Special Use Permit (SUP) Application Report

RE: Administrative Approval (COA-137360-2023) for 3820 Hermitage Road– New Garage material specifications

Site Plan
 3820 Hermitage Road - Detached Garage Plans
 Manuchehr and Rebecca A Amirsoleimani
 City of Richmond, VA

Building Permit - Approved Construction Documents
Under general authority of the Building Code, this approved set of construction documents shall be kept on the job site at all times and shall not be altered without approval from the Building Official. This permit does not approve any Electrical, Mechanical or Plumbing work. This approval does not relieve the builder from complying with manufacturer instructions, Virginia Uniform Statewide Building Code and City of Richmond regulations whether noted, implied or omitted. Approved Plans: 20231117_3320 Hermitage Rd. BLDR-126560-2023 12/13/2023 11:20:35 AM

2 Structural View

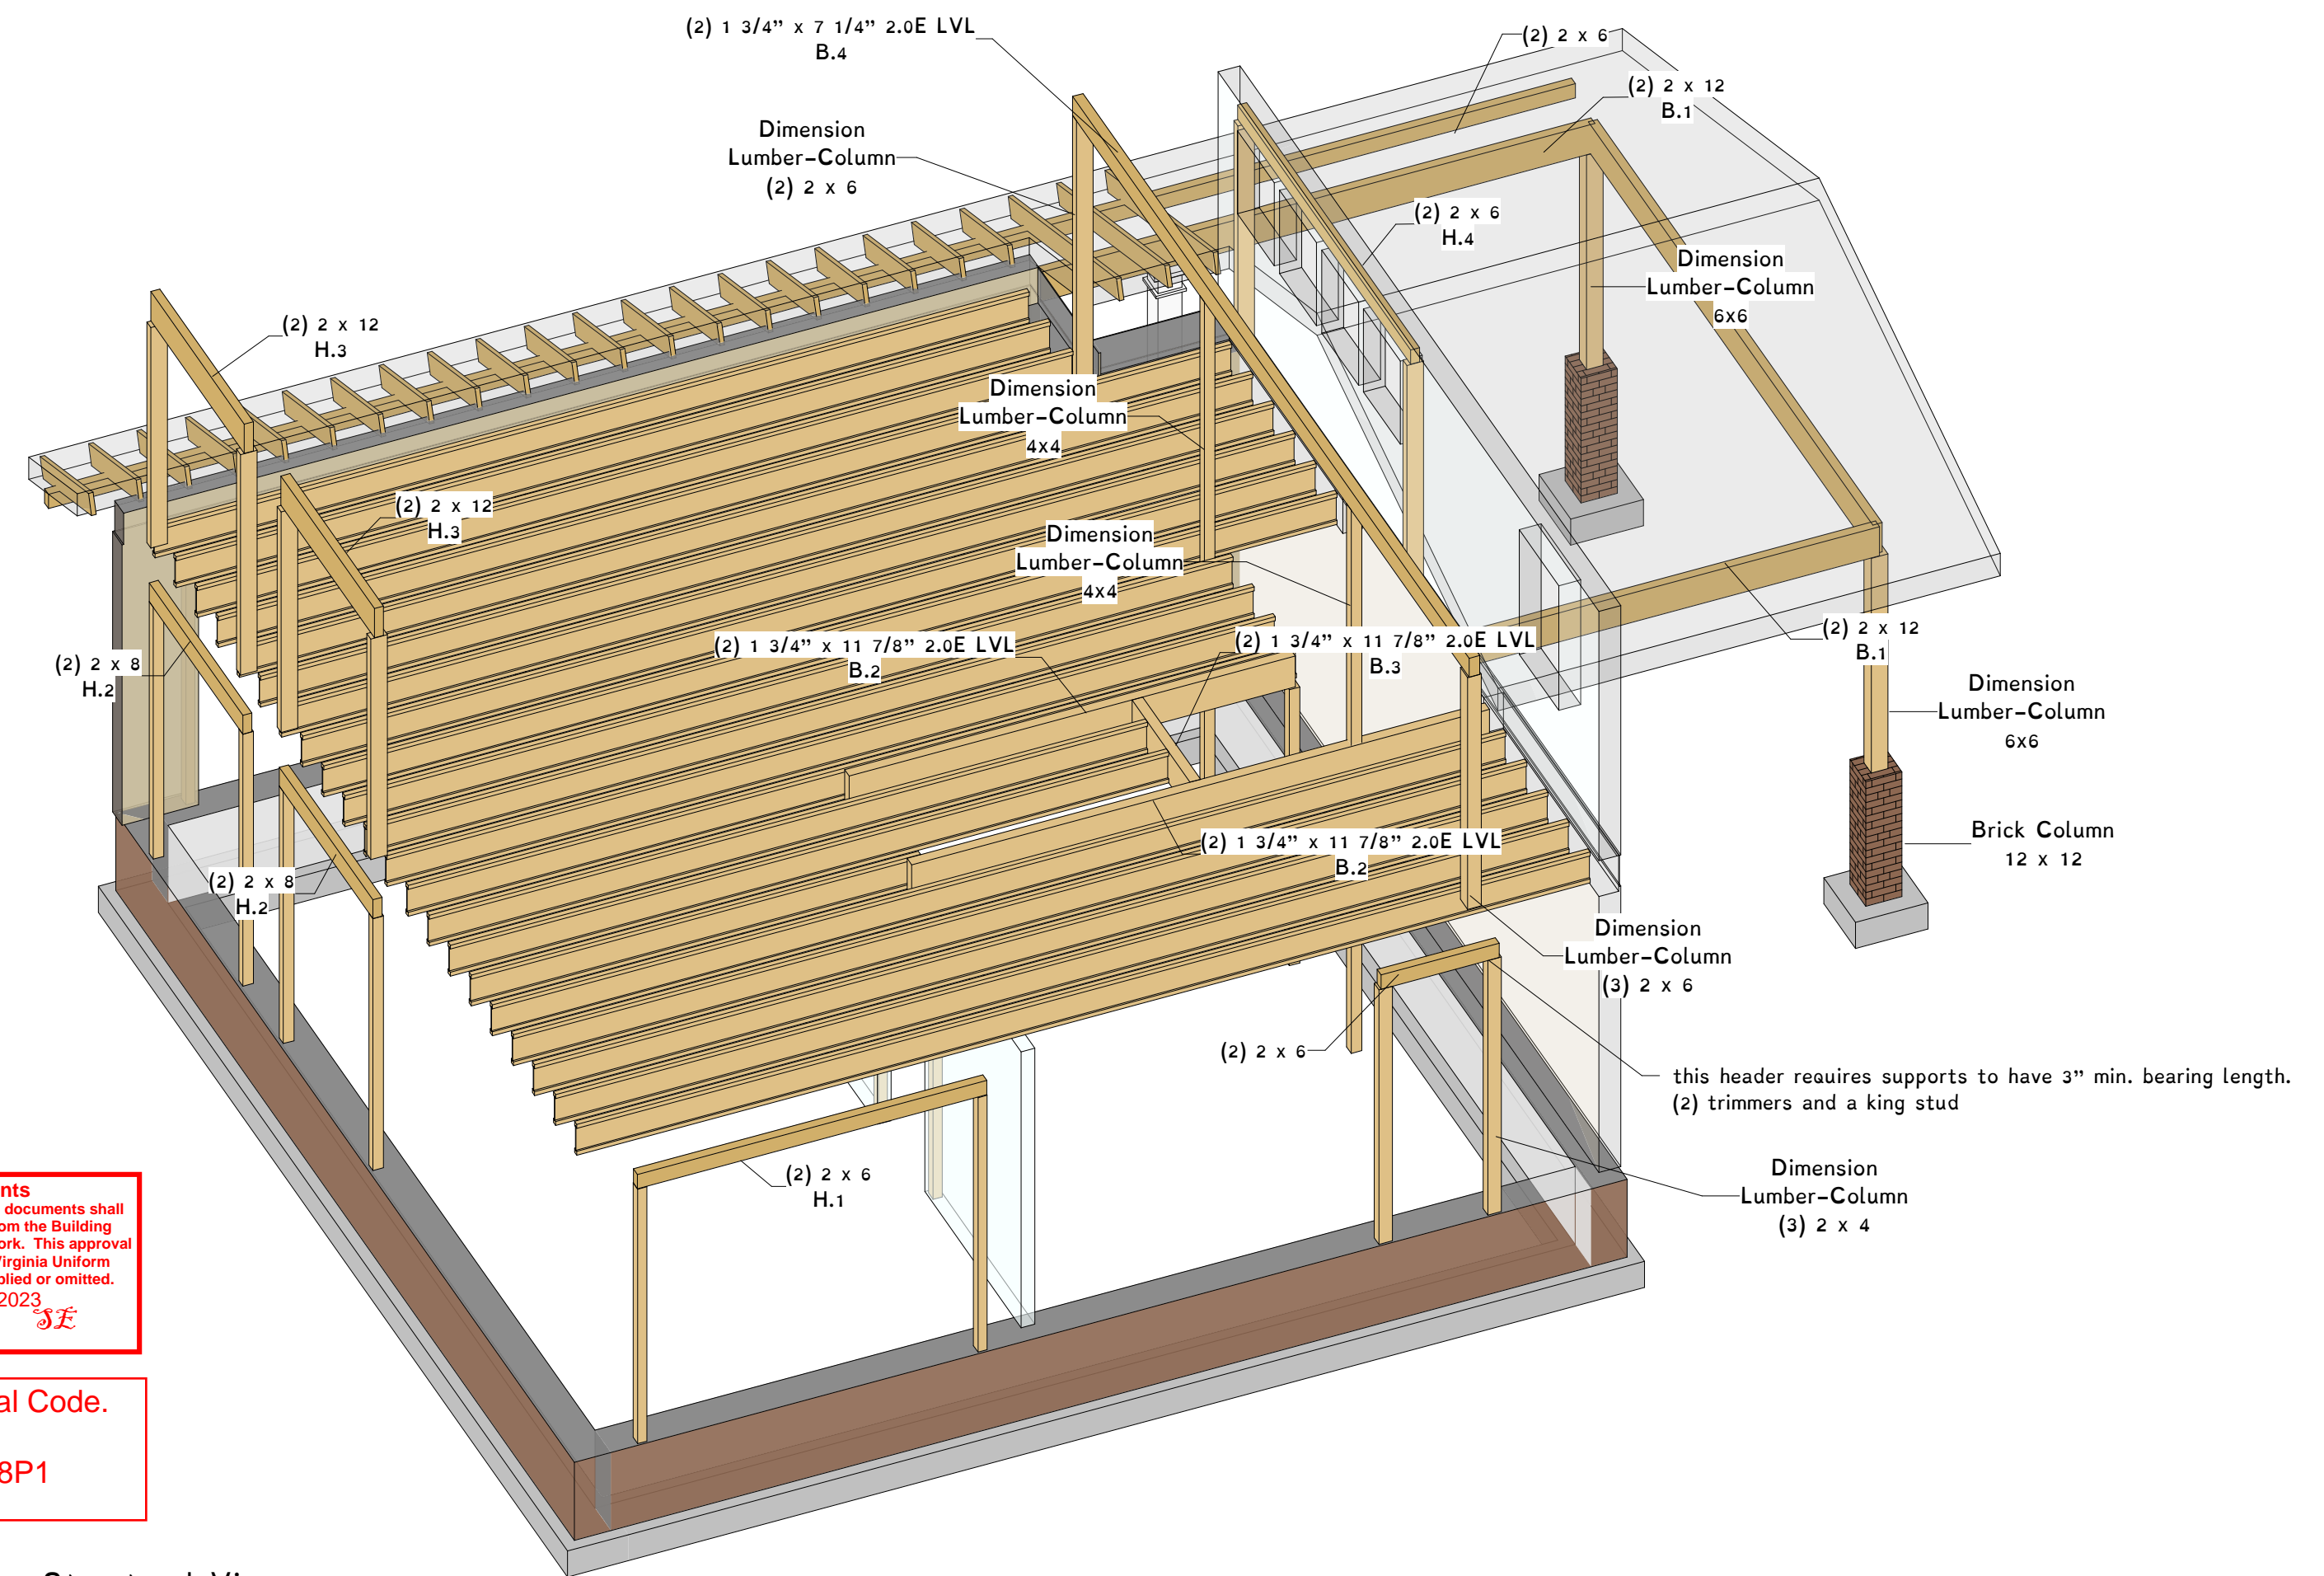
A manufactured trusses design shall be on site for review by the City of Richmond Building Inspectors.
